PRICE RIVER COAL COMPANY

December 16, 1985

*ACT/007/004
#2*

Further to our recent discussion concerning our mining permit and the various stipulations, perhaps it would be in order to review the entire process:

Figure 3.3-15

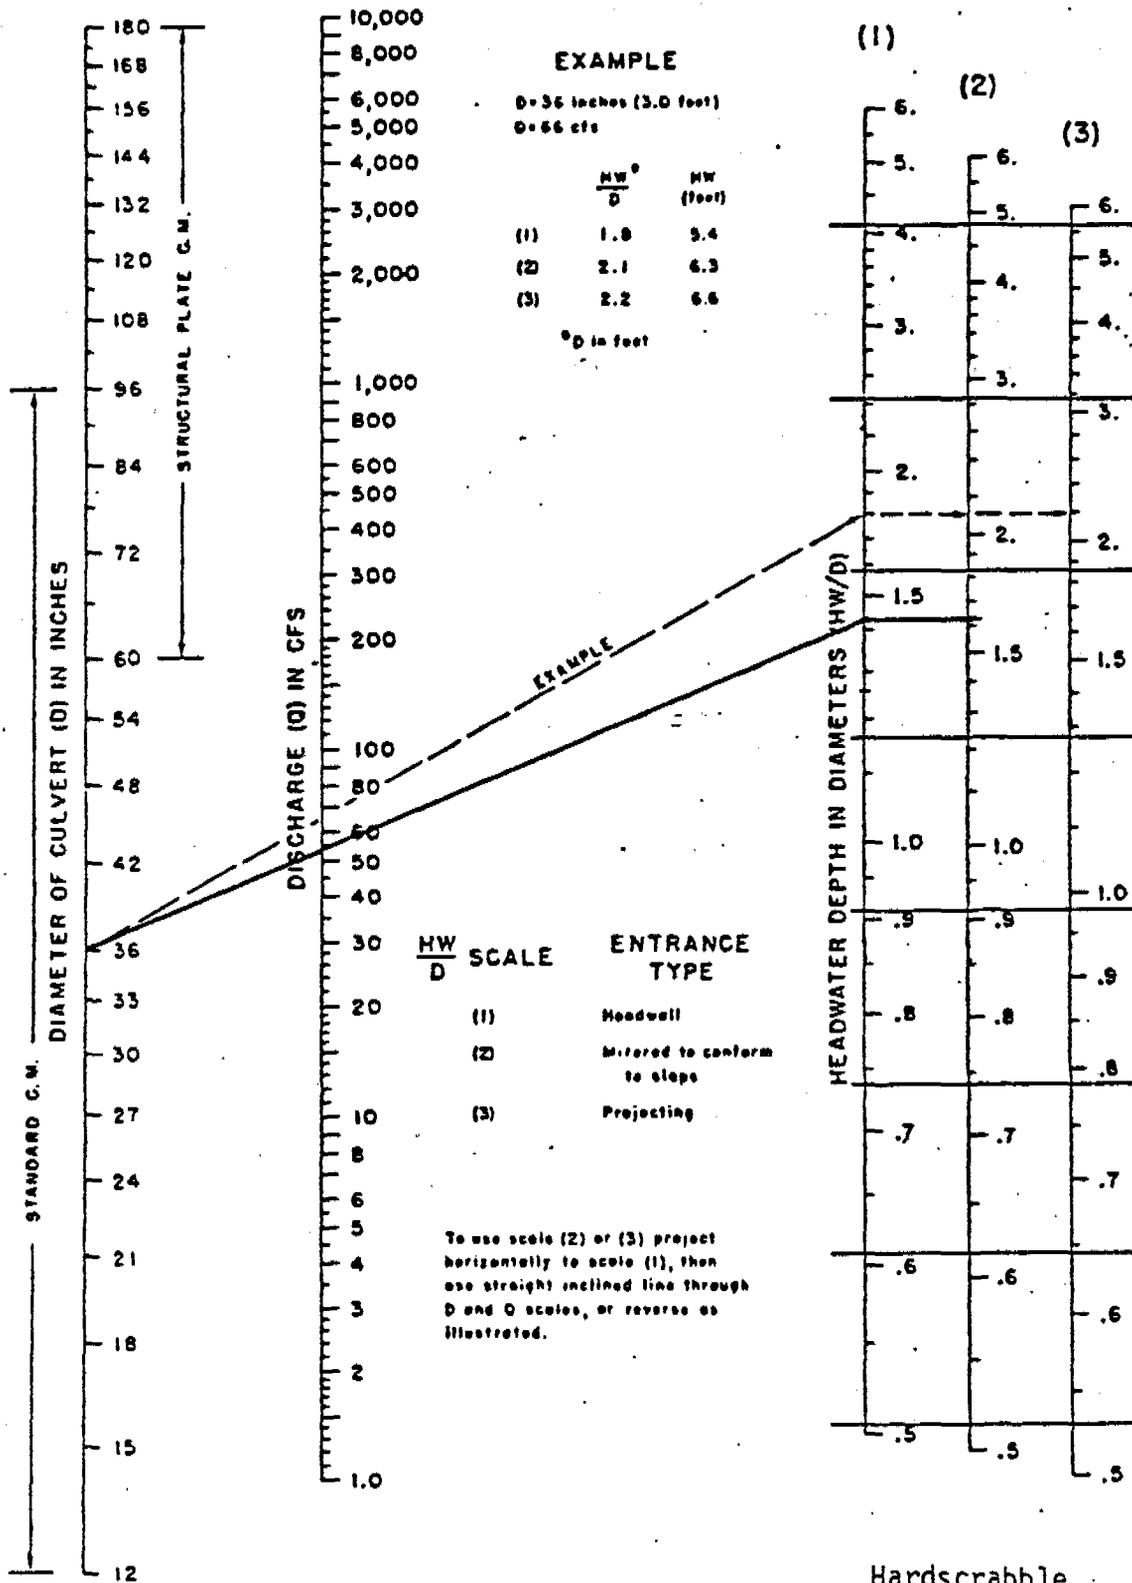
Should reclamation of Hardscrabble not continue according to plan, the following structures will be upgraded: Culverts C-3 and C-4 and Diversion D-6. Attached Exhibit 3.3-10 shows location and design details for upgraded structures C-3 and C-4. Design details for Culverts C-3 and C-4 and Diversion D-6 in Hardscrabble Canyon and Culverts C-3 and C-10 are provided as follows: Designs are based on information, formulae and assumptions found in Chapter VII, pp. 7-61 through 7-76.

Culvert C-3 - For undisturbed drainage area HC-3

Area: 61.3 acres

Peak Discharge: 23.18 cfs - 10-yr/24-hr storm

Try 36" cmp with 5' H.W., mitred headwall
(see attached nomograph; Figure 3.3-15)

Flow capacity about 54 cfs; adequate

Chart 2-53: HEADWATER DEPTH FOR C.M.P. CULVERTS WITH INLET CONTROL

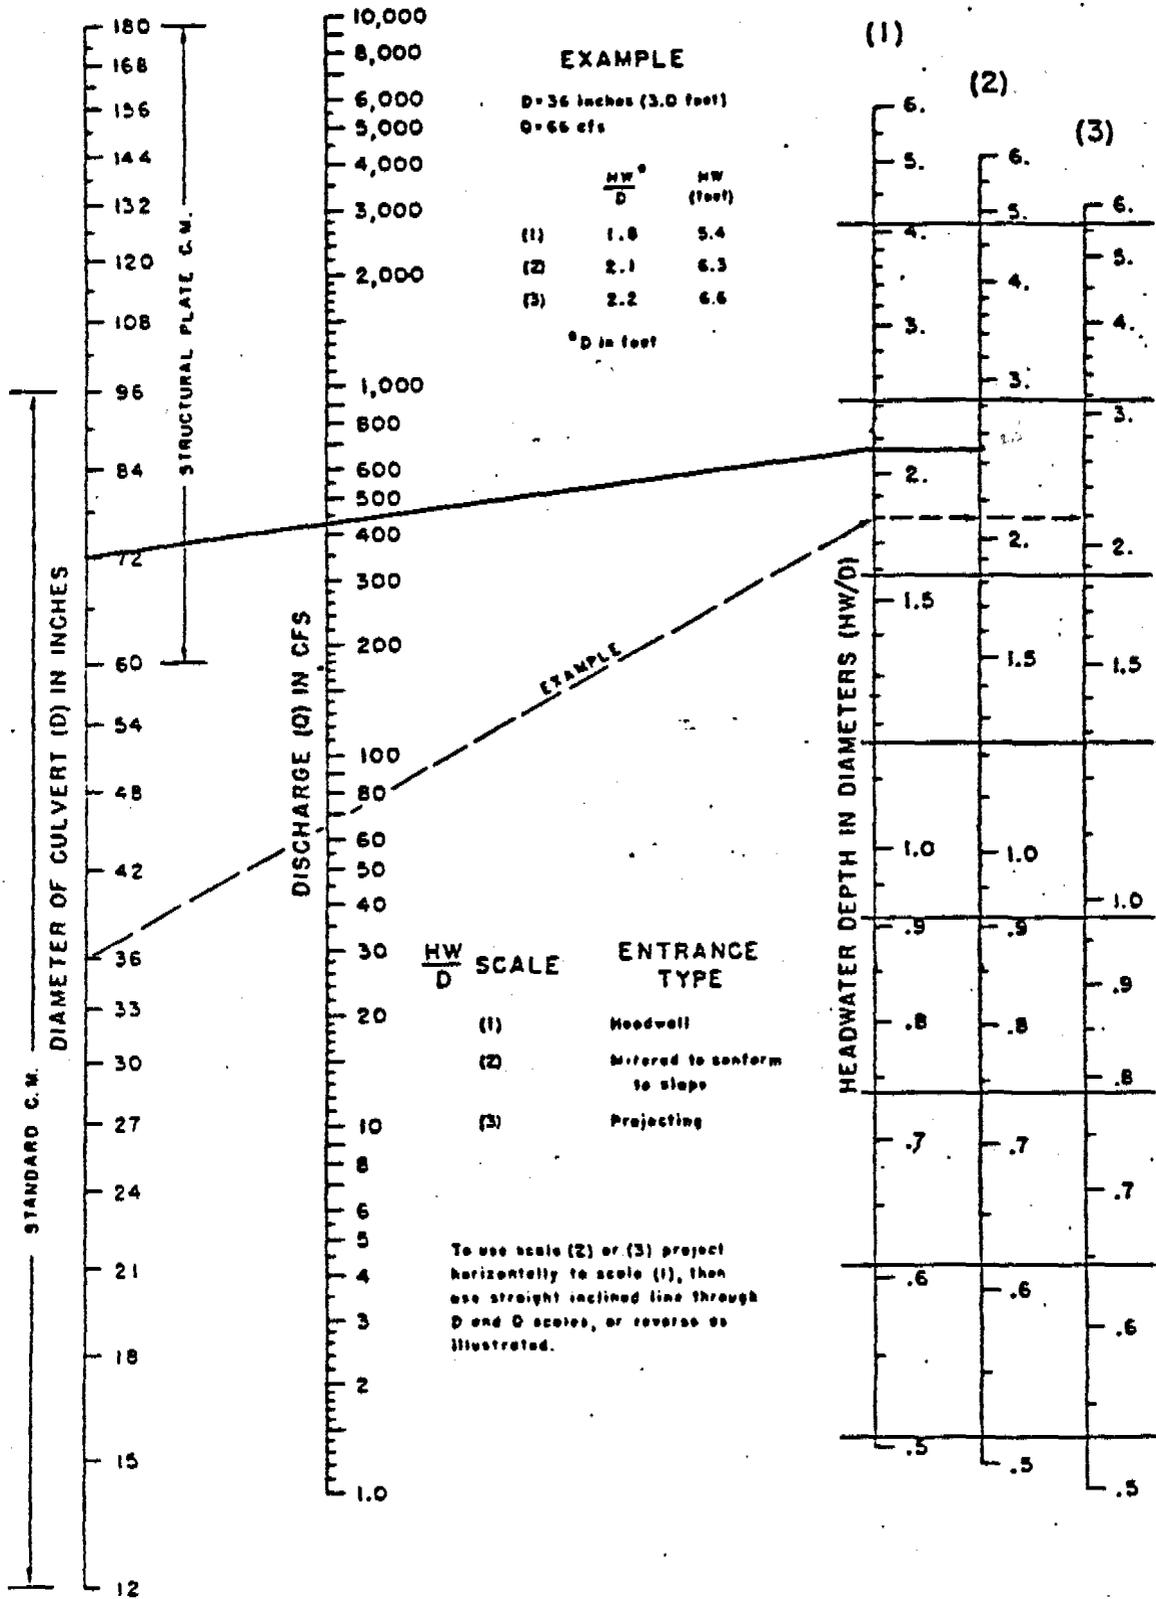
Culvert C-4 - For undisturbed drainage areas HC-9, 4, 5, 3, 8

Area: 625.1 acres

Peak Discharge: 207.22 cfs - 10-yr/24-hr storm

Try 72" cmp with 15' H.W., mitred headwall
(see attached nomograph; Figure 3.3-16)

Flow capacity about 425 cfs; adequate

PORTAL SEALING DOWN DIP METHOD

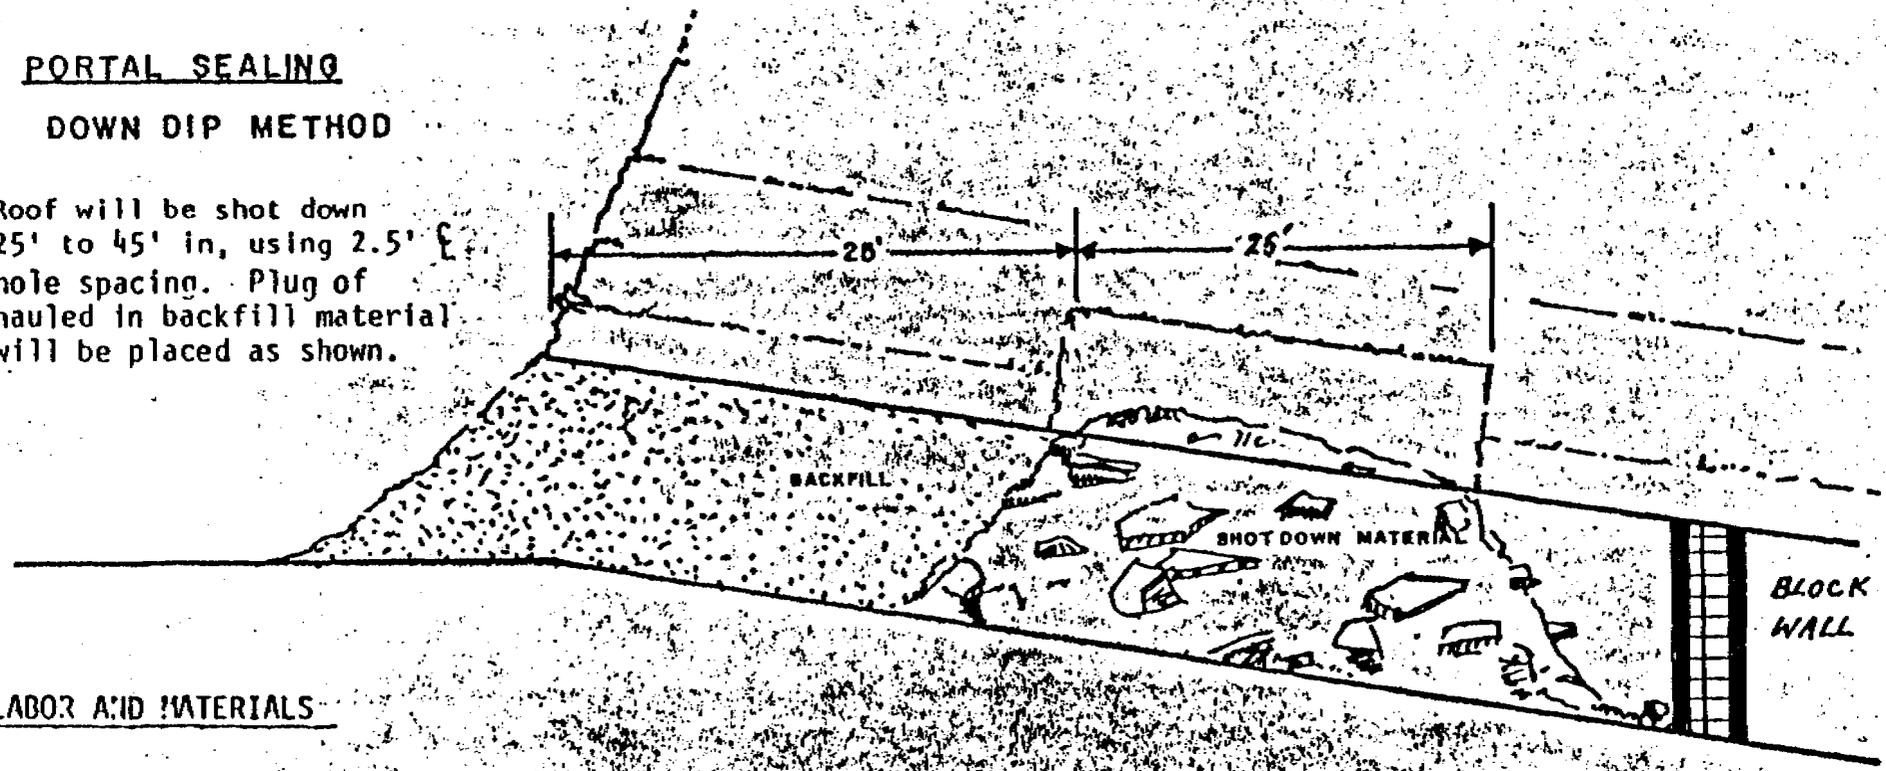
Within ninety (90) days of permit approval, the applicant must submit a permanent portal-sealing plan for approval by the regulatory authority. The applicant must also notify the Bureau of Land Management to arrange for on-site inspections and reviews between management and personnel from the Branch of Solid Minerals at least ninety (90) days prior to the proposed closing date of any portal.

The portal sealing plan included in PRCC's MRP (pp. 3-62, 3-63) has been reviewed with BLM's Allen Vance in the Price Utah office (11-84) and is changed according to the attached replacement Figures 3.1-3 and 3.1-4.

Roof will be shot down 25' to 45' in, using 2.5' hole spacing. Plug of hauled in backfill material will be placed as shown.
